ENCLOSURE 2

MFN 14-064

Response to Request for Additional Information Re: GEH Licensing
Topical Report NEDE-33005P, Revision 0, “TRACG Application for
Emergency Core Cooling Systems / Loss-of-Coolant-Accident Analyses
for BWR/2-6”

**Figure R11-1 PCT Results for BWR/4 Large-Break LOCA
Using SAFER with App. K Assumptions**

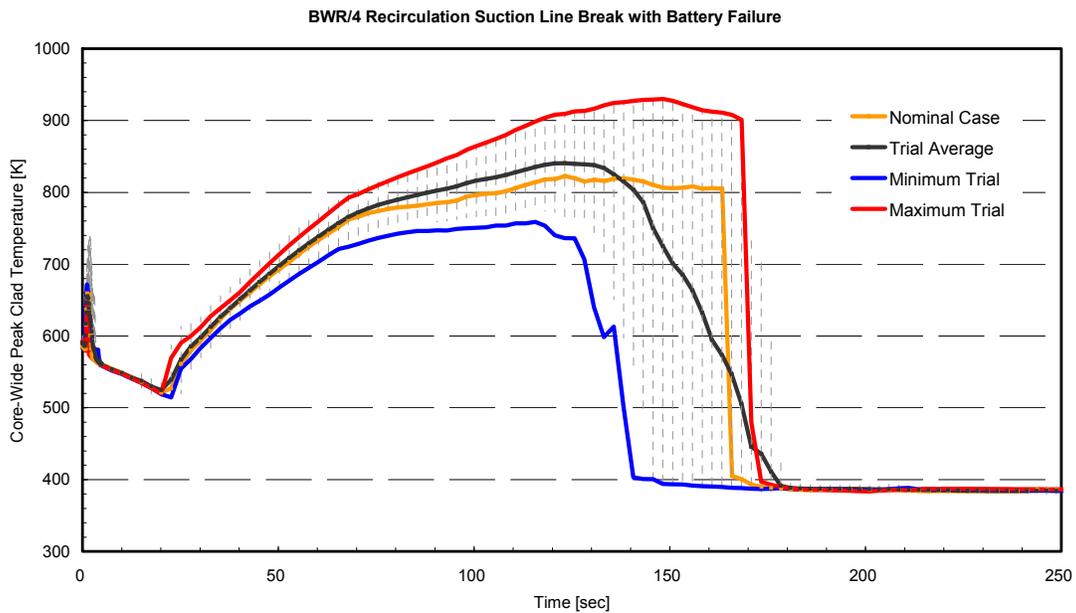
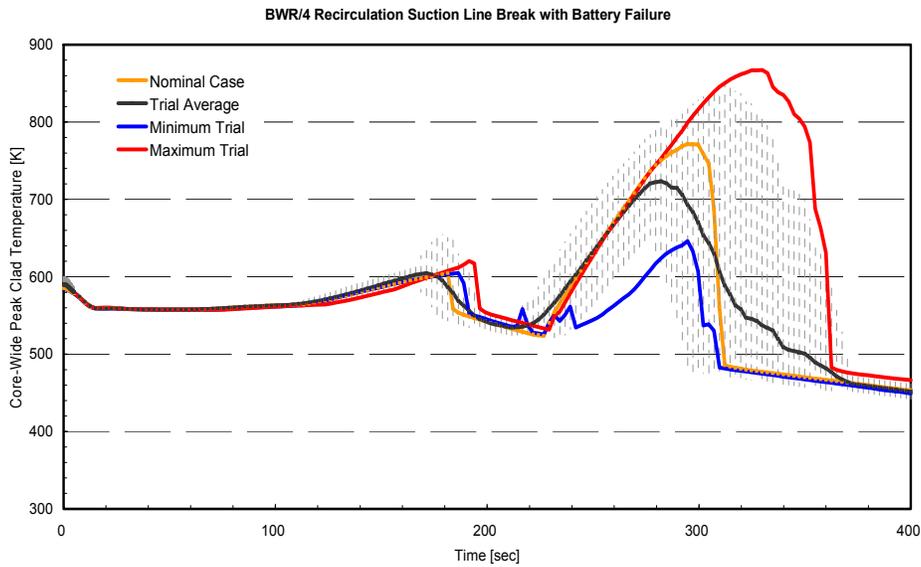
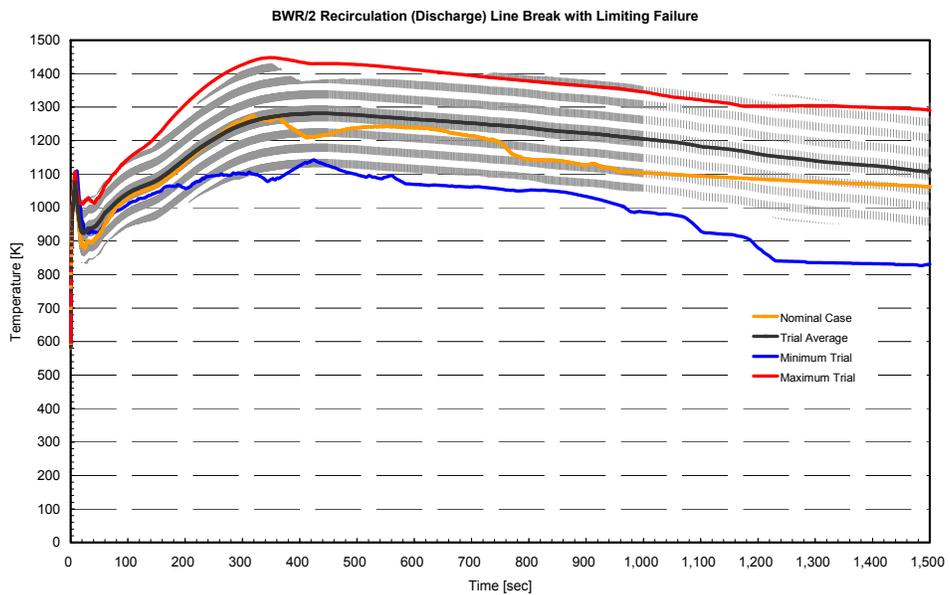
Figure R11-1 through R11-4 show the comparisons of PCTs predicted using the SAFER and the TRACG methodologies for similar BWR/4 plant types. Tables R11-1 and R11-2 show the comparisons of the PLHGRs, PCTs and oxidations from these two methods.

The comparisons between SAFER/CORCL and TRACG results for a BWR/2 type plant are also provided. The results are shown in Figure R11-5 and 11-6 and in Table R11-3. Note that the TRACG calculations used a higher PLHGR than the SAFER/CORCL calculation yet the PCT predicted by TRACG was lower than SAFER/CORCL.

Figure R32-1 A Typical BWR/2 ECCS Configuration

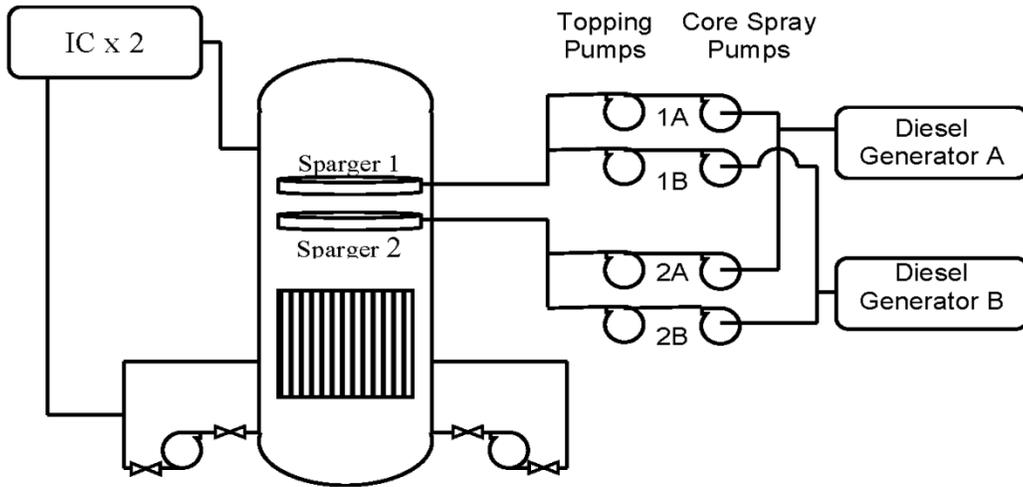
ECCS configuration for a typical BWR/2 is shown in Figure R32-1. In performing the ECCS performance analysis the postulated failure of a single active component will never result in less than certain minimum combinations of remaining operable systems.

For the scenario where the assumed single failure is one of the diesel generators, at least 2 Core Spray trains (2 sets of CS pump and booster pump) will remain available out of 4 CS trains shown in Figure R32-1. Any other single failure related to the CS pump, booster pump, CS lines, or sparger would still result in a minimum of two functional 2 CS trains (hence the analyzed minimum configuration crediting 2 CS trains is described as “single failure proof”). Assuming an additional booster pump failure (unless requested by customer for operational purposes) on top of the already assumed single failure makes the analyzed scenario beyond design basis because the scenario requires multiple failures. An example of a beyond-design-basis multiple failure scenario is DG failure (which takes 2 CS trains out) plus failure of a booster pump in one of the two remaining available CS trains.
